UNITED STATES PATENT AND TRADEMARK OFFICE

10/666,950

Office Action Summary	Application No.	Applicant(s)	
	10/666,950	OLVEY, SUSAN	
	Examiner	Art Unit	
	Philip Gabler	3637

DETAILED ACTION

**FIG. 1****FIG. 2****FIG. 3****FIG. 4****FIG. 5**

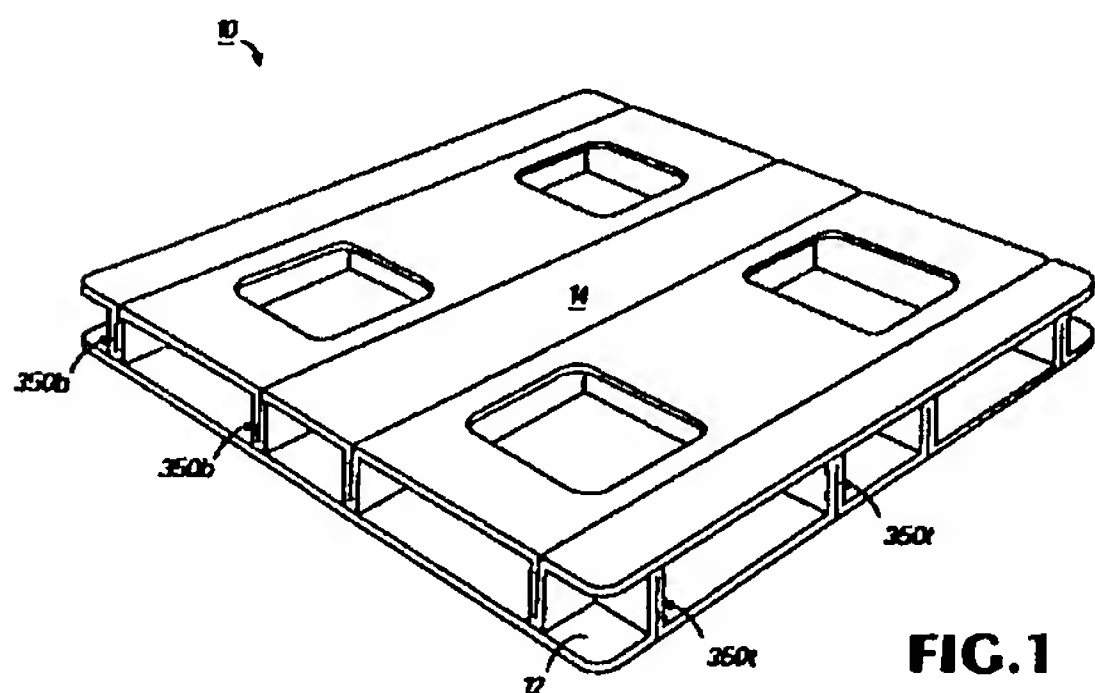
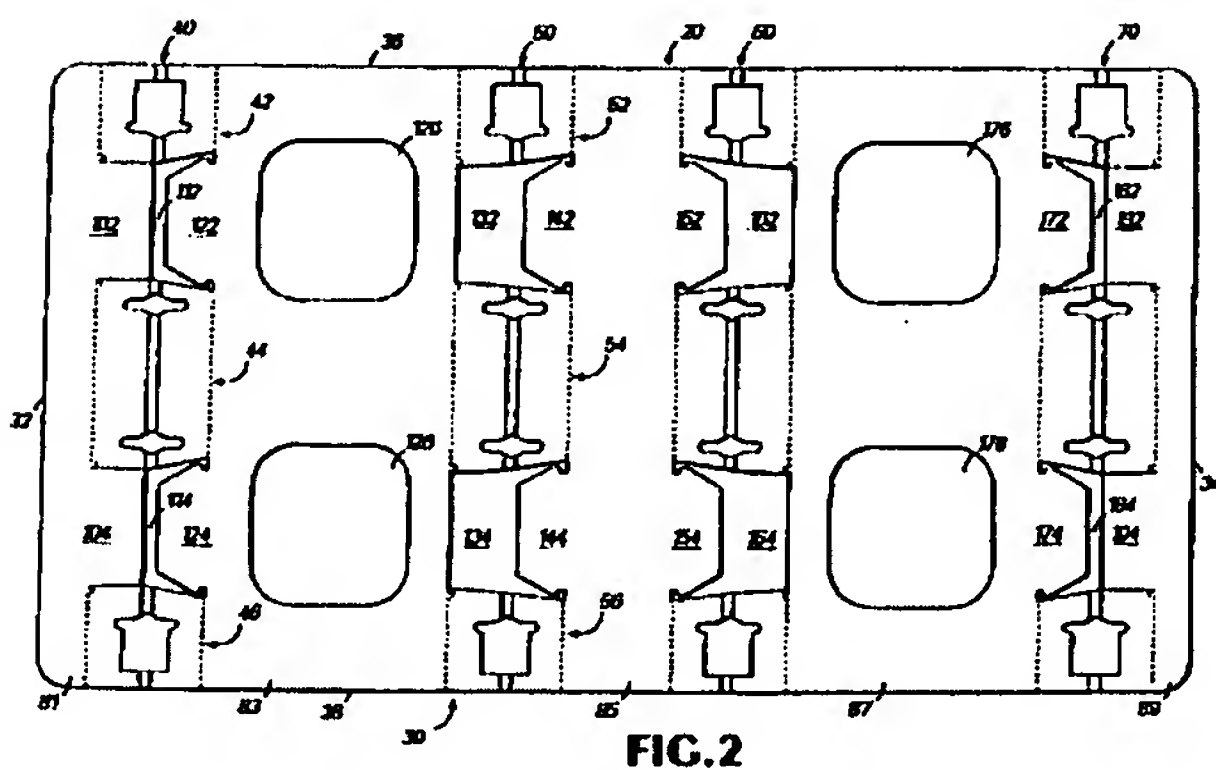
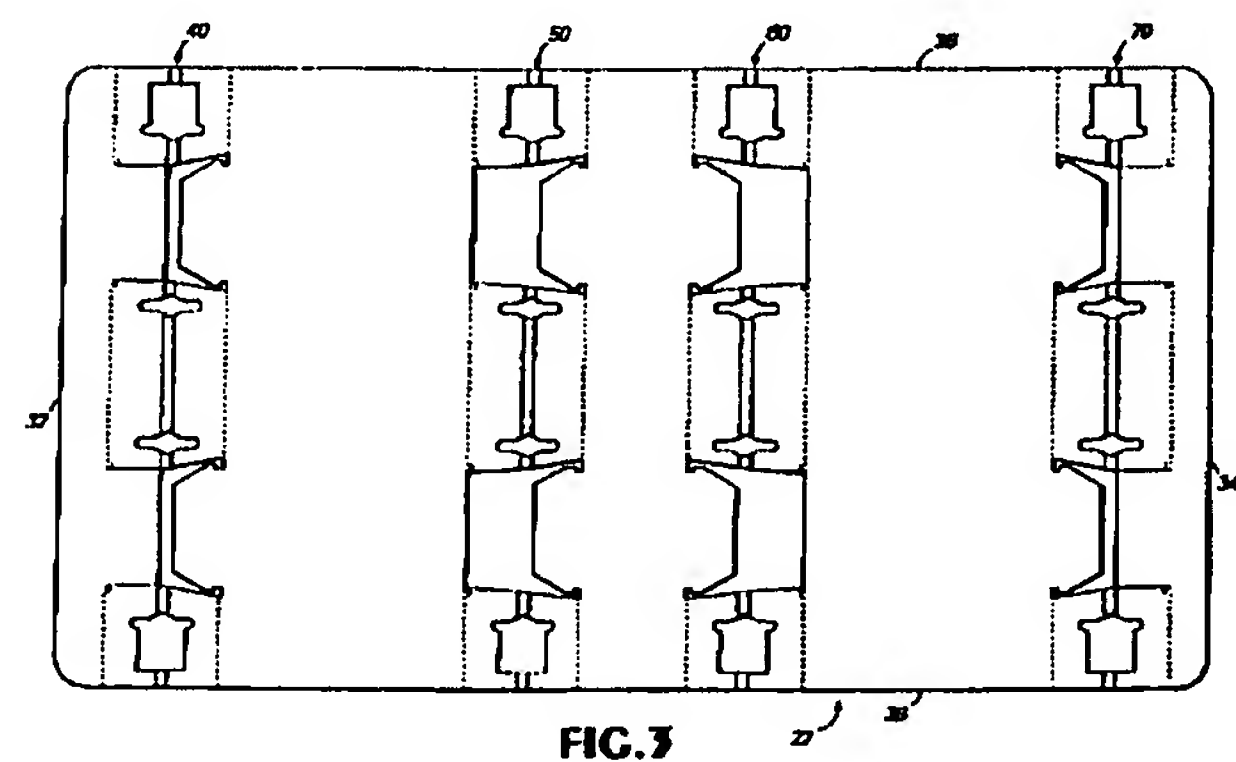
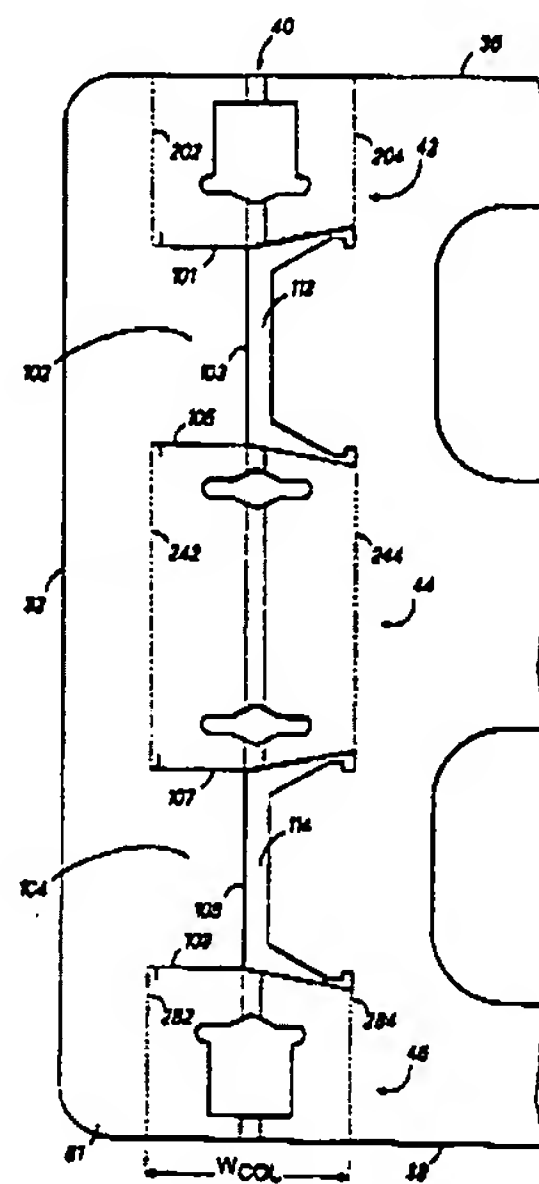
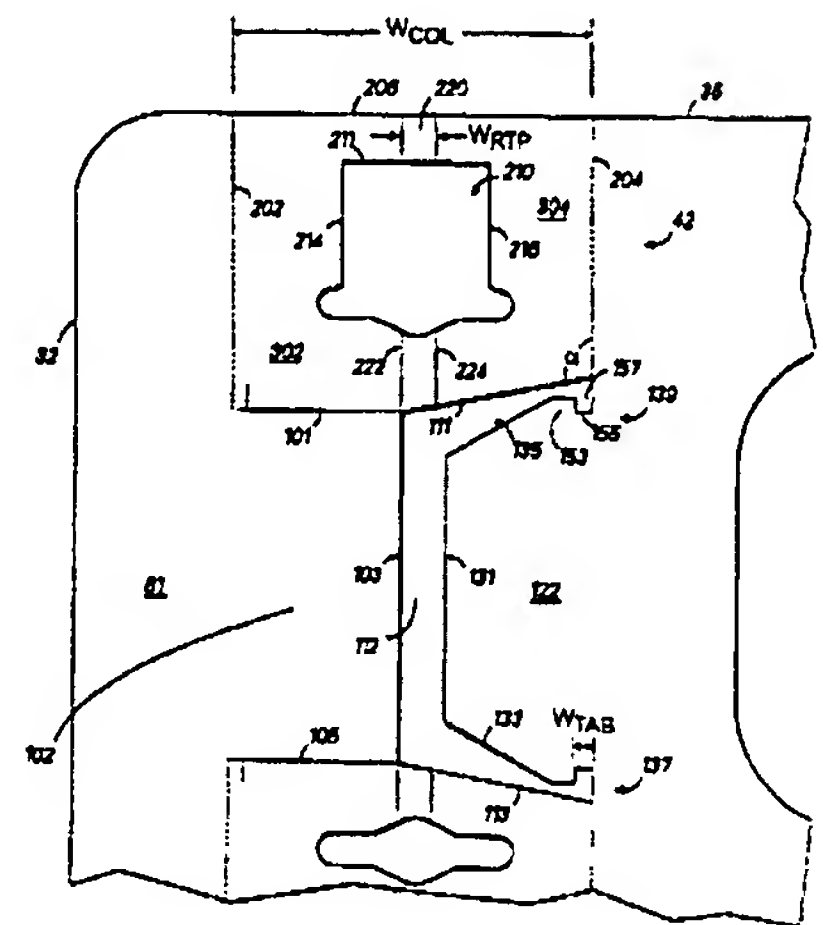
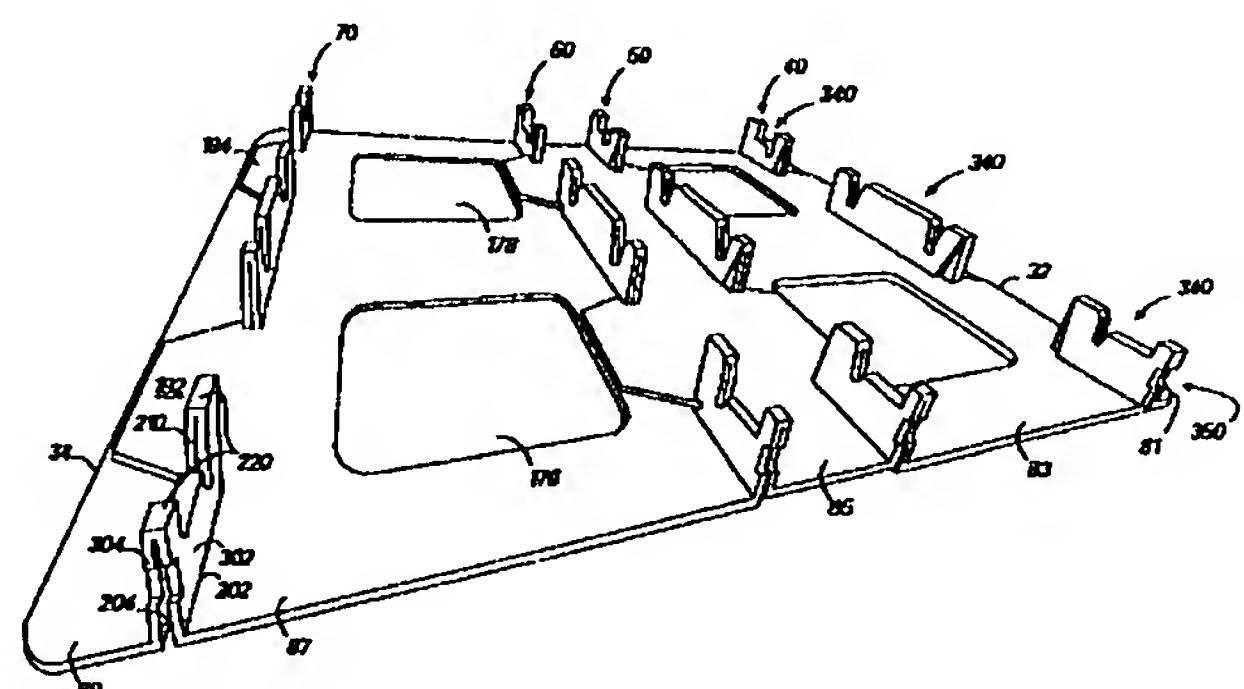
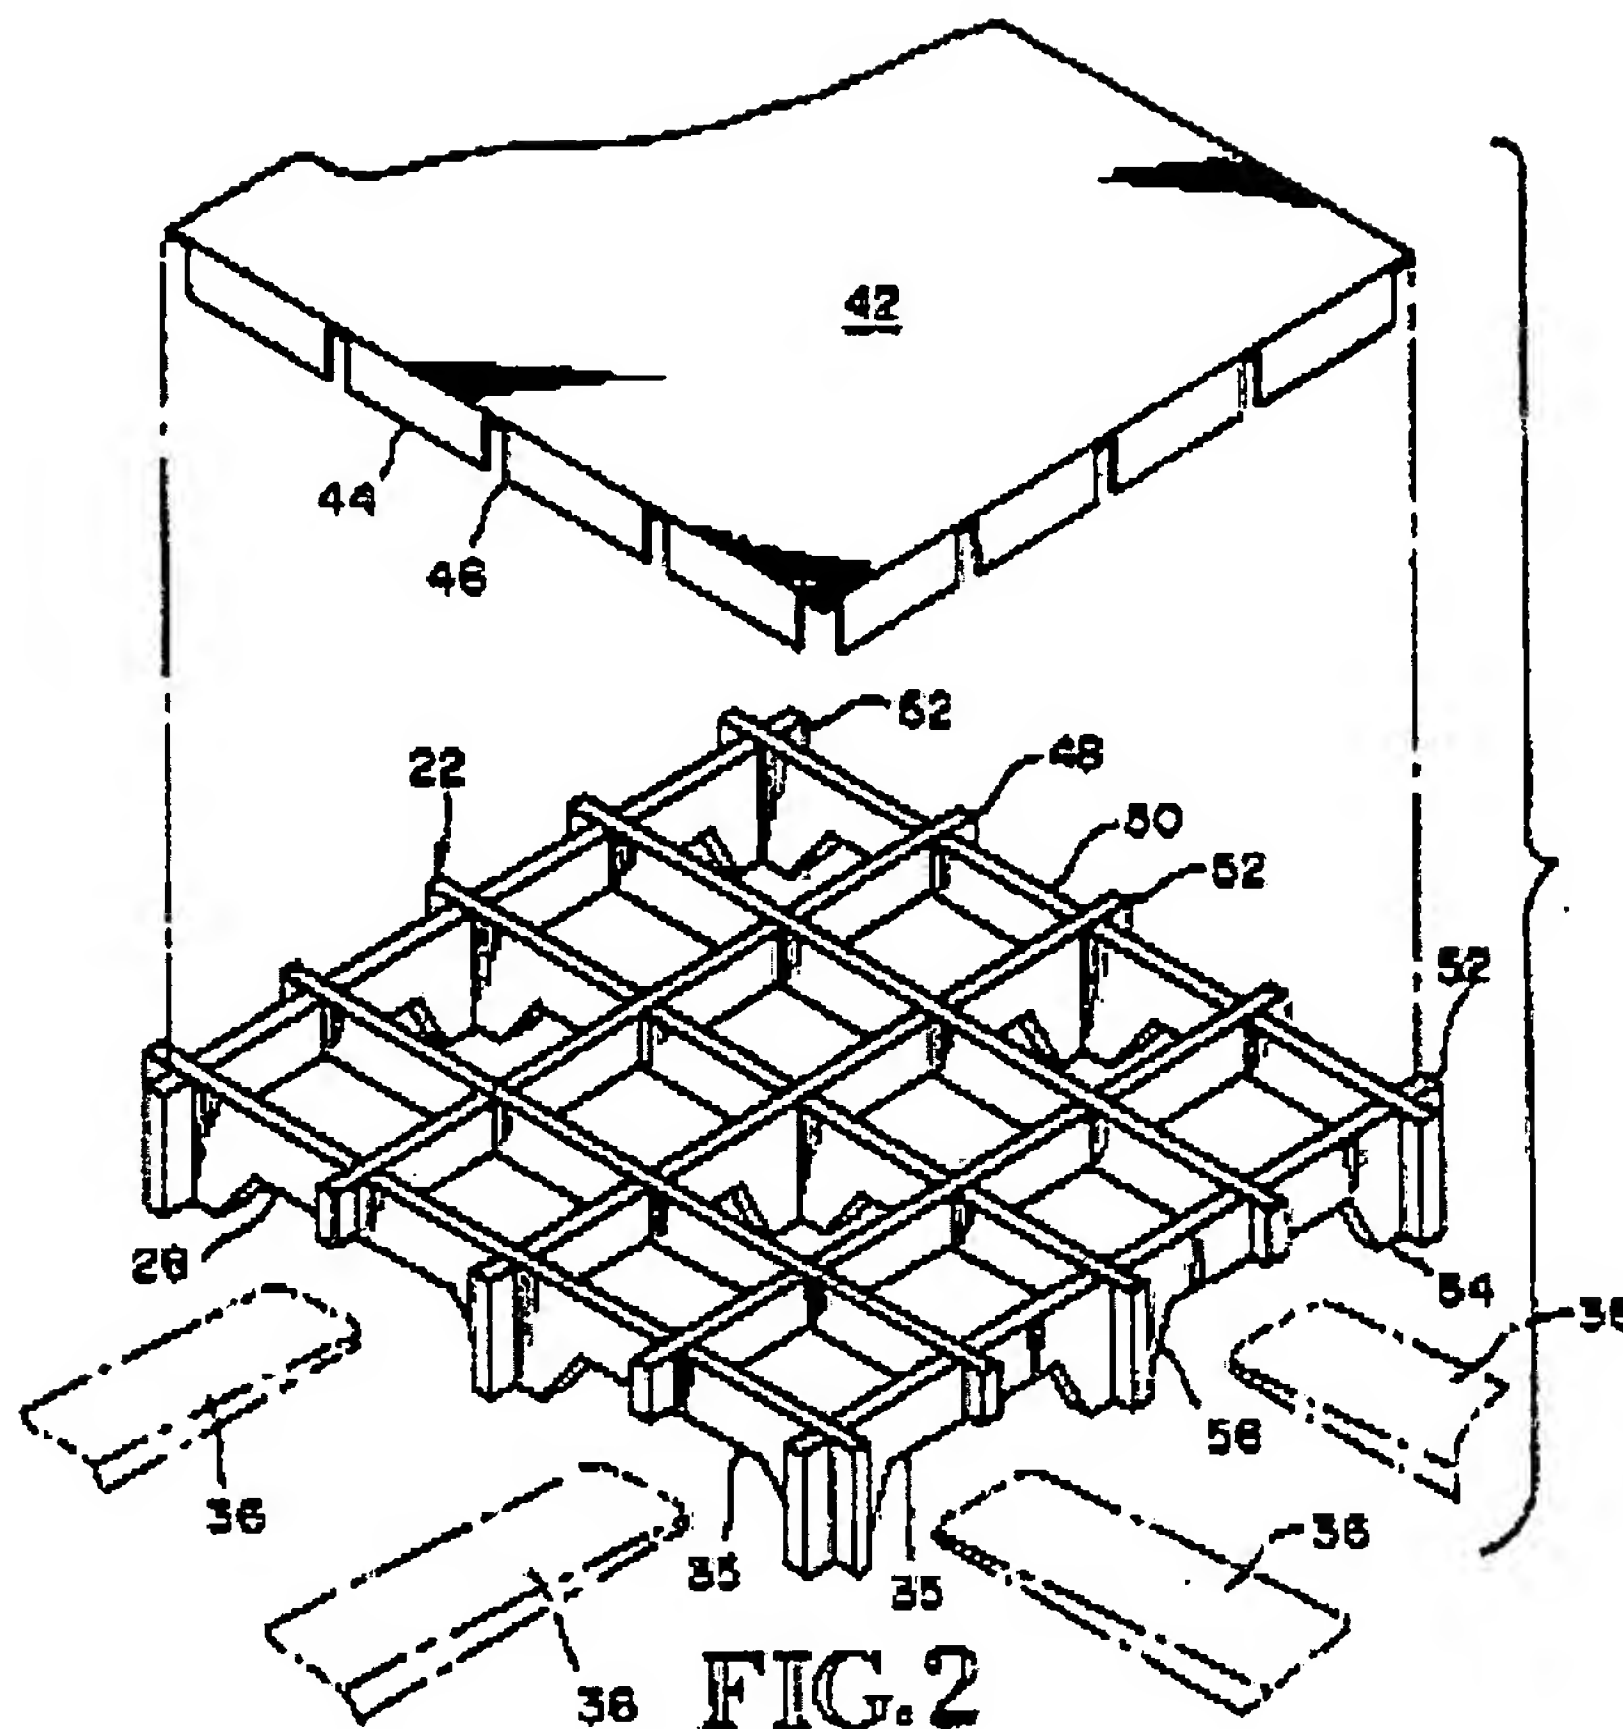
11. Regarding claims 1 and 4, Ogilvie (Figures 1-5 and 9) discloses a force resisting corrugated assembly foldably constructed from a generally flat blank, the blank having top and bottom ends and sides upon folding, said assembly comprising: a first assembled frame (20), said first frame comprising at least two jack panels (83, 87); at least three ribs (formed by 40, 50, 60), said ribs formed by folding said blank at predetermined locations and locked into place by folding lock assemblies (122, 142, etc. and associated components); and first and second edge panels (81, 89) defined on first and second ends, respectively, of said first frame; and a second frame (22), said second frame comprising at least two jack panels; at least three ribs, said ribs formed by folding said blank at predetermined locations and locked into place by folding lock assemblies; and first and second edge panels defined on first and second ends, respectively, of said second frame (the jack panels, ribs, etc. as in the first frame); wherein said ribs of first and second frames comprise locking slots (210, etc.); wherein said first and second frames are brought together in a perpendicular fashion such that the ribs of the first frame lock into place with the ribs of the second frame (see figures).

12. Regarding claim 2, Ogilvie further discloses folding lock assemblies comprise wing tabs (153) to secure said ribs into place.

13. Regarding claim 3, Ogilvie further discloses two jack panels (83, 87) and four ribs (formed from 40, 50, 60, 70).

14. Regarding claim 5, Ogilvie further discloses said edge panels of said first and second frames are folded over (at 202, etc.) and secured into place (by 102, etc.) before, during, or after the ribs of said first and second frames are locked into place.

15. Regarding claim 6, Ogilvie further discloses said first and second frames comprise tab locks (153) defined near the periphery of said first and second frames; and edge panels comprise tab holes (formed by 101, etc.); wherein said tab locks and said tab holes are positioned such that tab locks are pushed through tab holes upon edge panels being secured into place, whereby said tab locks increase the holding strength of said edge panels.

18. Regarding claim 18, Ogilvie discloses a method of constructing a force-resistance corrugated assembly comprising obtaining a first and second frame (each comprising the structural limitations as claimed, see above) and interlocking said first and second frames by bringing them together in a perpendicular fashion such that their ribs lock (see column 16 line 23 to column 17 line 59).

19. Regarding claim 19, Ogilvie discloses a lock assembly to lock the orientation of an upwardly extending rib (formed by 40) foldably constructed from a flat column (40) of a blank, said lock assembly comprising first and second panels (81, 83) on either side of the flat column, and a flap (122) extending from one of said first or second panels, wherein said flap comprises at least two wing tabs (153) on opposing sides of said flap,

wherein upon folding said first and second panels toward each other, the column folds into the upwardly extending rib, the rib having rib sides with side edges (at ends of rib), wherein said flap folds over said first or second panel and wherein said wing tabs can be raised then pressed down to secure rib into place.

Haywood et al. '241 Figures 2 and 8

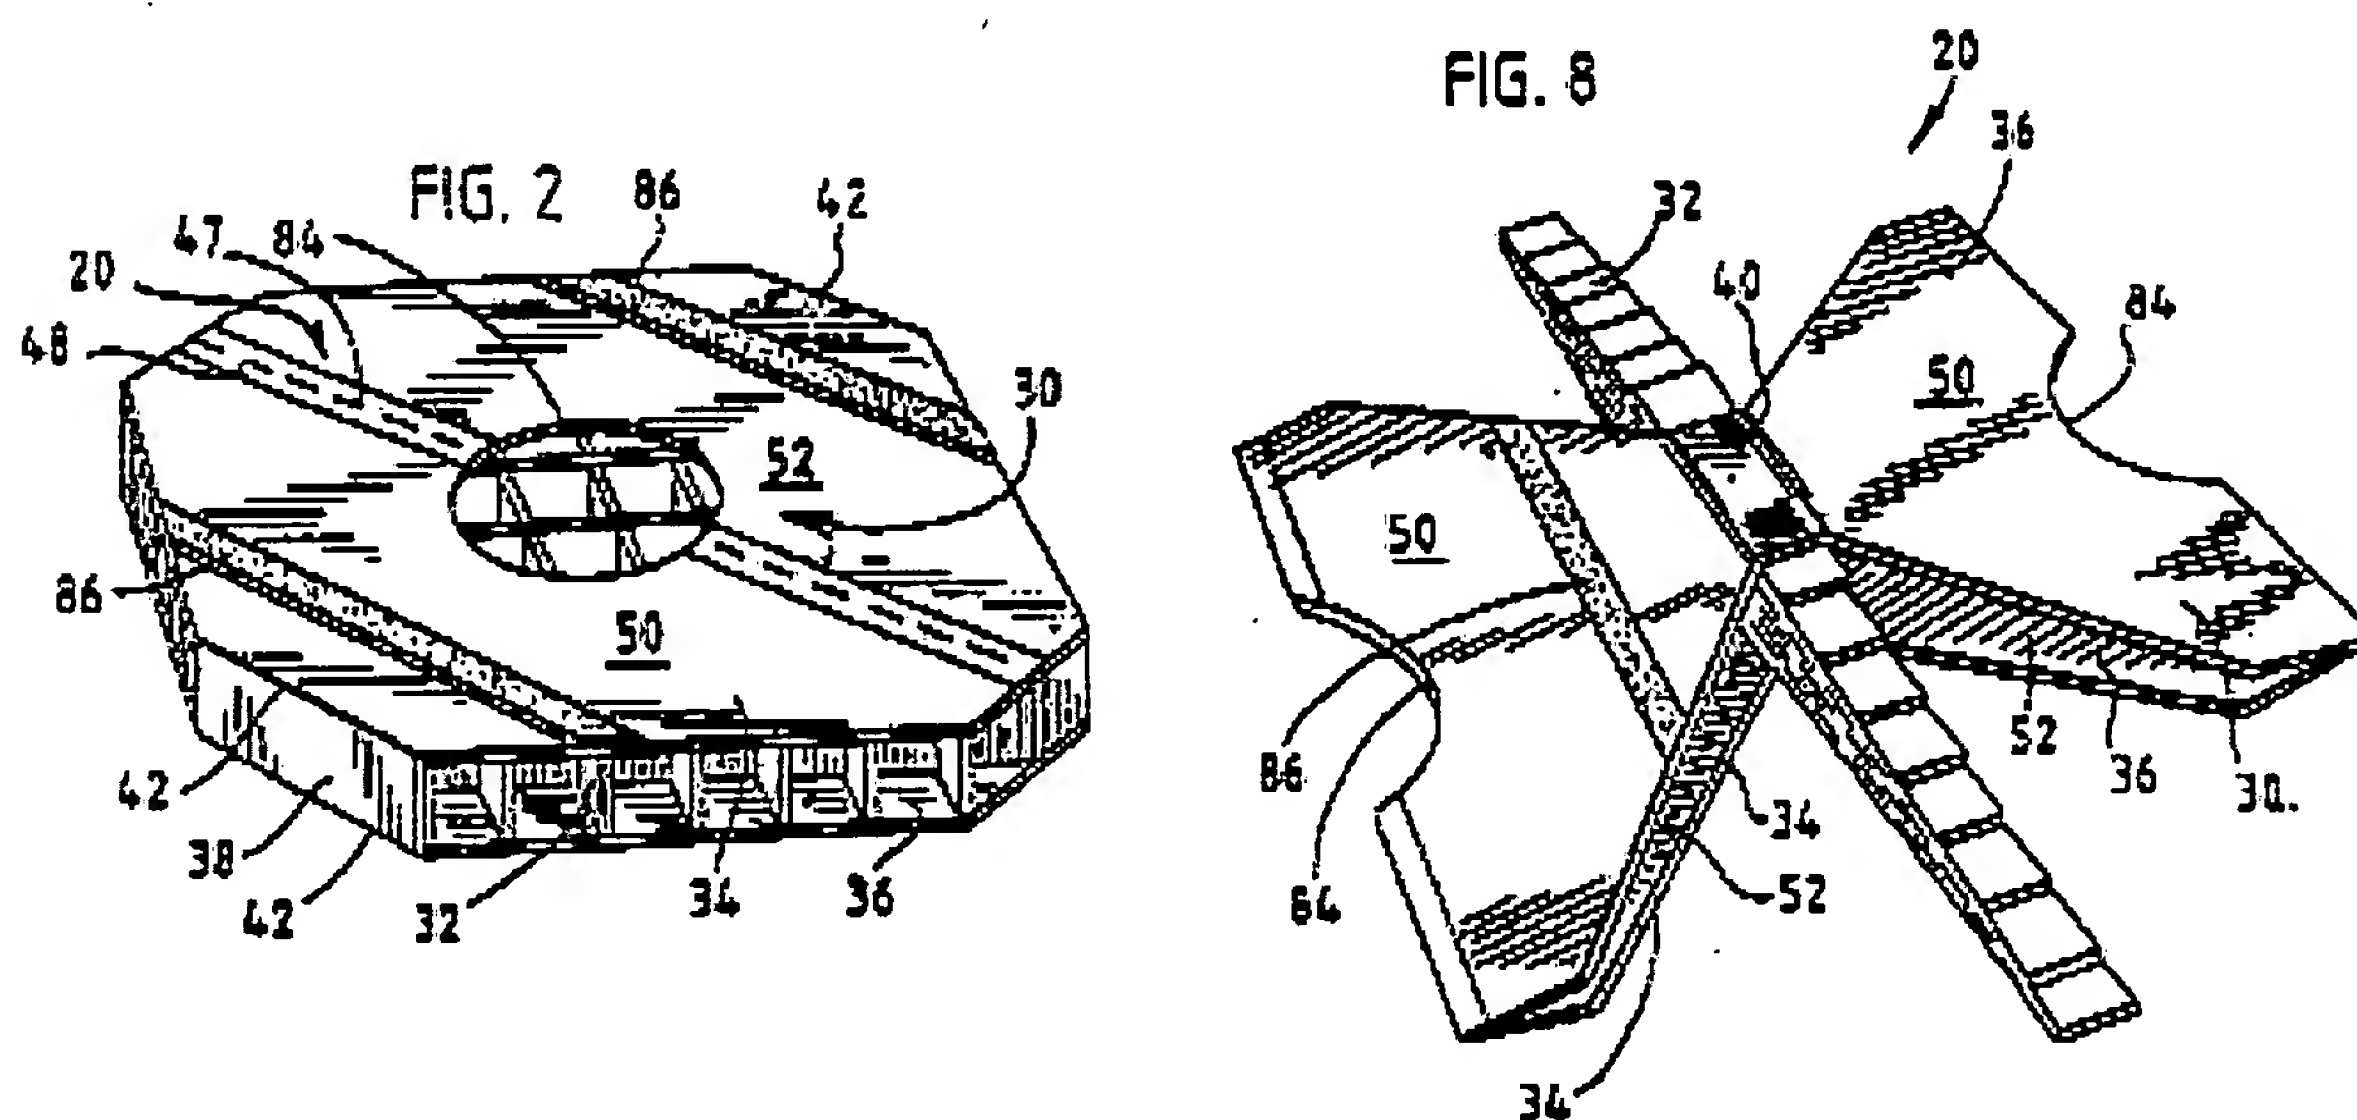
20. Claims 7 and 12 are rejected under 35 U.S.C. 102(b) as being anticipated by Haywood et al. (US Patent Number 5484241). Haywood (Figures 2 and 8) discloses a force resisting corrugated assembly foldably constructed from a generally flat blank, said assembly configured to be assembled into the shape of an octagon.
